UNITED STATES PATENT AND TRADEMARK OFFICE

APPLICATION NO.	FILING DATE	FIRST NAMED INVENTOR	ATTORNEY DOCKET NO.	CONFIRMATION NO.
10/709,715	05/24/2004	Kuo-Hsing Cheng	11586-US-PA	3714
31561 7590 06/18/2008 JIANQ CHYUN INTELLECTUAL PROPERTY OFFICE 7 FLOOR-1, NO. 100 ROOSEVELT ROAD, SECTION 2 TAIPEI, 100 TAIWAN				
EXAMINER MOON, SEOKYUN				
ART UNIT 2629		PAPER NUMBER		
NOTIFICATION DATE 06/18/2008		DELIVERY MODE ELECTRONIC

Office Action Summary

DETAILED ACTION

Drawing 1

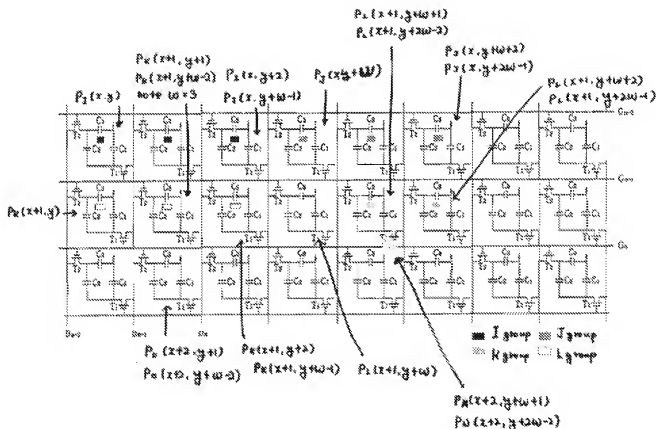
As to **claim 1**, Lee teaches a driving method for a pixel array [fig. 3], at least one row of the pixel array comprising a plurality of pixel sets (note that the display of Lee includes a plurality of parts having a structure shown on fig. 3 and drawing 1 is provided on page 4 of this Office Action for illustration of the plurality of parts having the structure), and at least one of the pixel sets comprising a plurality of pixels (three consecutive pixels), the driving method [drawing 1, which is equivalent to fig. 3] comprising:

driving pixels $PI(x,y)$, $PK(x+1,y+1)$, $PI(x,y+2)$, ..., $PK(x+1,y+W-2)$, $PI(x,y+W-1)$, $PJ(x,y+W)$, $PL(x+1,y+W+1)$, $PJ(x,y+W+2)$, ..., $PL(x+1,y+2W-2)$, $PJ(x,y+2W-1)$ by a first gate line (" G_n-I "), wherein K th, J th, and L th pixel sets adjacent to the I th pixel set comprise W pixels respectively, wherein a I th pixel set comprises W pixels, a pixel of the I th pixel set in x th row and y th column is expressed as $PI(x,y)$ and I , W , x , y , K , J , and L are integers; and

driving pixels, $PK(x+1,y)$, $PO(x+2,y+1)$, $PK(x+1,y+2)$, ..., $PO(x+2,y+W-2)$, $PK(x+1,y+W-1)$, $PL(x+1,y+W)$, $PN(x+2,y+W+1)$, $PL(x+1,y+W+2)$, ..., $PN(x+2,y+2W-2)$, $PL(x+1,y+2W-1)$ by a second gate line (" G_n "), wherein O th and N th pixel sets adjacent to the K th and L th pixel sets comprise W pixels, and O , N are integers.

Lee does not expressly teach the method comprising providing a plurality of voltages having substantially same phase to a plurality of pixel electrodes of the pixels of one of the pixel sets and providing at least two voltages with phases substantially opposite to each other to the pixel electrodes of the pixels of two of the adjacent pixel sets respectively.

However, Noguchi teaches a concept of using three-dots polarity inversion method to drive a liquid crystal display panel [col. 12 lines 32-36], wherein the three-dots polarity inversion method provides a plurality of voltages having substantially same phase to a plurality of pixel electrodes of the pixels of a pixel set (the pixel set comprising R, G, B pixels) and provides at least two voltages with phases substantially opposite to each other to the pixel electrodes of the pixels of two of the adjacent pixel sets respectively.

It would have been obvious to one of ordinary skill in the art at the time of the invention to modify the driving method of Lee to use three-dots polarity inversion method, as taught by Noguchi, in order to prevent changes on the polarizations of liquid crystals caused by applying data voltages having same polarity to the pixels for a long time period.

As to **claim 2**, Lee as modified by Noguchi teaches each of the pixel sets comprising three pixels [drawing 1 provided above].

As to **claim 3**, Lee as modified by Noguchi teaches a number of the pixels of each of the pixel sets being $3 \times M$, wherein M is a positive integer [drawing 1 provided above].
